Project	IEEE 802.16 Broadband Wireless Access Working Group < http://ieee802.org/16 >	
Title	Efficient and Secure Security Framework in PKMv2	
Data Submitted	2005-03-16	
Source(s)	Seokheon Cho, Sungcheol Chang, Chulsik Yoon, ETRI Sanjay Bakshi, Yigal Eliaspur, Intel Corporation Junhyuk Song, Jicheol Lee Samsung	Voice: +82-42-860-5524 Fax: +82-42-861-1966 chosh@etri.re.kr sanjay.bakshi@intel.com junhyuk.song@samsung.com
Re:	IEEE P802.16e/D6	
Abstract	The existing PKMv2 is somewhat unorganized and insecure security framework. This contribution provides a resolution for unorganized and insecure issues in the PKMv2.	
Purpose	Adoption of proposed changes into P802.16e/D6	
Notice	This document has been prepared to assist IEEE 802.16. It is offered as a basis for discussion and is not binding on the contributing individual(s) or organization(s). The material in this document is subject to change in form and content after further study. The contributor(s) reserve(s) the right to add, amend or withdraw material contained herein.

Efficient and Secure Security Framework in PKMv2

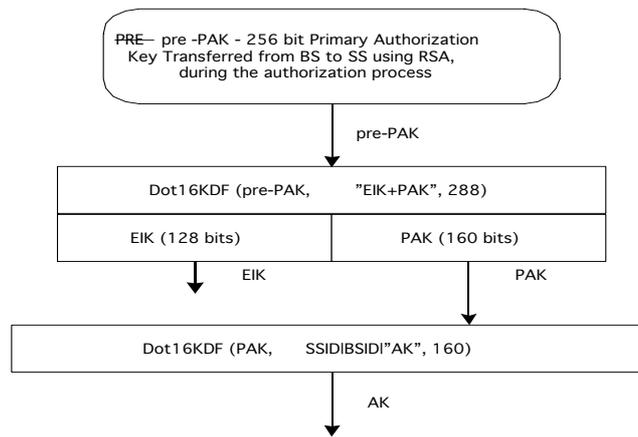
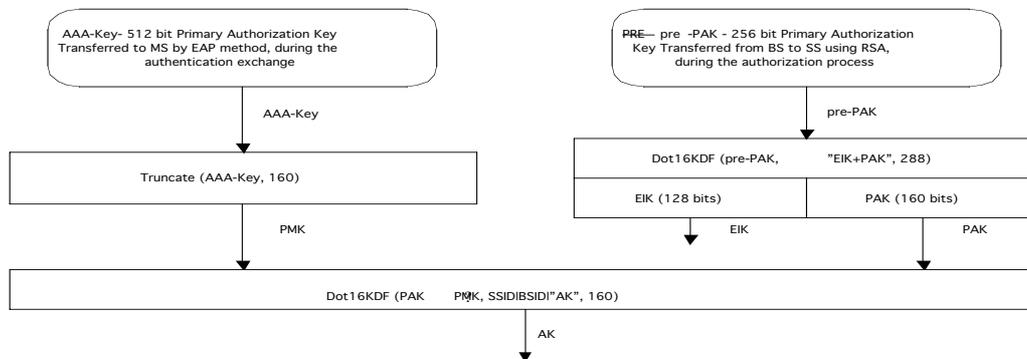
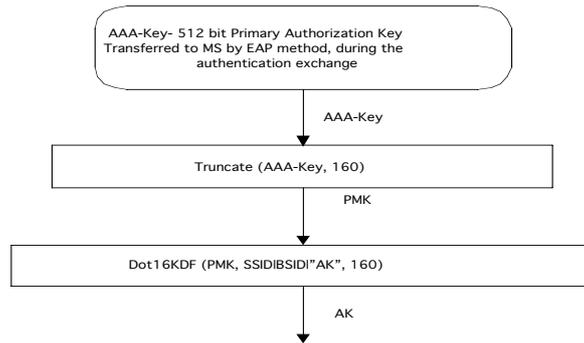
- The AK is derived from PAK or/and PMK which are generated and distributed from the BS and Authenticator, respectively.
- The input key used for AK generation is the PMK. The PAK should be also used to generate the AK as not input data but an input key.

- a) The input key for generating the AK should be both PMK and/or PAK. The exclusive-or (XOR: \oplus) value of PAK and PMK as input key is used to generate the AK. The generation method of the AK is as follows.

If (RSA-based authorization and EAP-based authorization)
 $AK \leq \text{Dot16KDF}(\text{PAK} \oplus \text{PMK}, \text{SSID|BSID|"AK"}, 160)$
 Else if (RSA-based authorization)
 $AK \leq \text{Dot16KDF}(\text{PAK}, \text{SSID|BSID|"AK"}, 160)$
 Else if (EAP-based authorization)
 $AK \leq \text{Dot16KDF}(\text{PMK}, \text{SSID|BSID|"AK"}, 160)$

Figure 131-AK with the only ~~RSA-based~~ authorization process

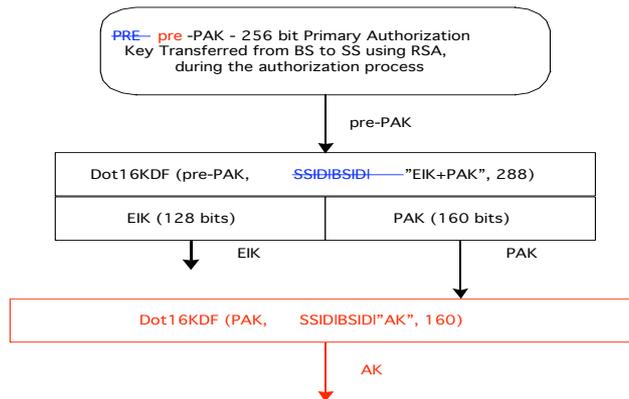
Figure 131 outlines the process to calculate the AK when the ~~RSA-based~~ authorization process has taken place, but where the EAP-based authentication process hasn't taken place, or the EAP method used has not yielded an AAA-key:

Figure 132-AK with RSA and EAP authorization process

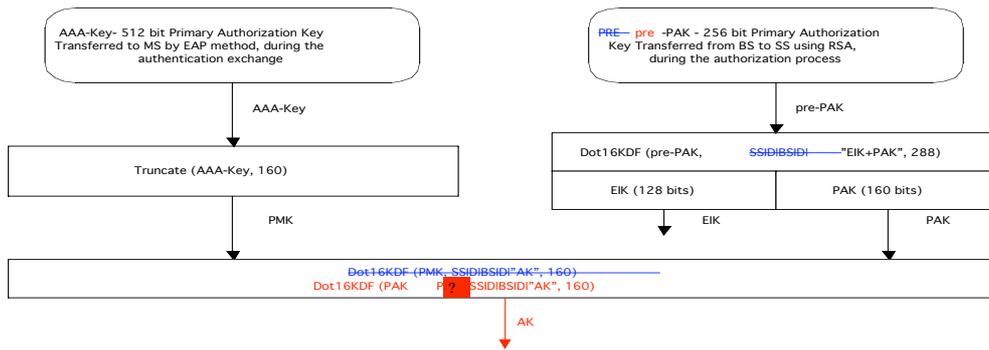
Figure 132 outlines the process to calculate the AK when both the ~~RSA-based~~ authorization exchange has taken place, yielding a PAK and the EAP based authentication exchange has taken place, yielding an AAA-key:
